Whangateau Harbour Esplanade Reserve

Asbestos Management Plan 2020

Document Addendum to Whangateau Harbour Esplanade Reserve (refer **Appendix B**)

Rev	Revision Date	Details	Authorised	
			Name/Position	Signature
A	24-June-2021	Addendum Review to address Auckland Council comments on sections 4.2.2 (ongoing management), 4.3 (areas where asbestos was determined not to be present) and 7.2 (asbestos related work).	Caroline Secretin Principal Environmental Scientist

PROJECT NUMBER
60602006
SHEET TITLE
AREA OF LONG-TERM
MANAGEMENT
MAP NUMBER
FIGURE 3

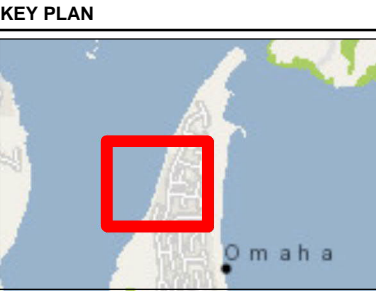
⁶ **Changes reflected in the Addendum:** This *area of proposed remedial works* consists of the western edge of the Esplanade strip, and represents approx. 75% of the total length (north/south) of the Esplanade strip.

⁸ **Changes reflected in the Addendum:** Mowing – only if there is no known or suspected asbestos-containing material on the surface of the area being mown. That is, no mowing in the *area of proposed remedial works* (refer to **Figure 3 in Appendix A**) and confirming the remainder of the Esplanade Strip surface is free of asbestos-containing material and as per Section 4.2 a maintenance plan should be established, which can include a mowing monitoring regime and PPE requirements for operators.

Longer-term management of materials and/or areas where asbestos has been presumed present will largely depend on whether any planned future works disturb these materials and/or areas. The area requiring long-term management consideration is presented in **Figure 3** in **Appendix A**, with the *area of proposed remedial works* indicative of where asbestos is more likely to be present. This *area of proposed remedial works* consists of the western edge of the Esplanade strip, and represents approx. 75% of the total length (north/south) of the Esplanade strip.

- Walking over;
- Spray-application of pesticide/herbicide;
- Surface deposition of fertiliser;
- Grass sowing; and
- Collection of incidentally-deposited or windblown refuse.
- Mowing – only if there is no known or suspected asbestos-containing material on the surface of the area being mown. That is, no mowing in the *area of proposed remedial works* (refer to **Figure 3 in Appendix A**) and confirming the remainder of the Esplanade Strip surface is free of asbestos-containing material and as per Section 4.2 a maintenance plan should be established, which can include a mowing monitoring regime and PPE requirements for operators.
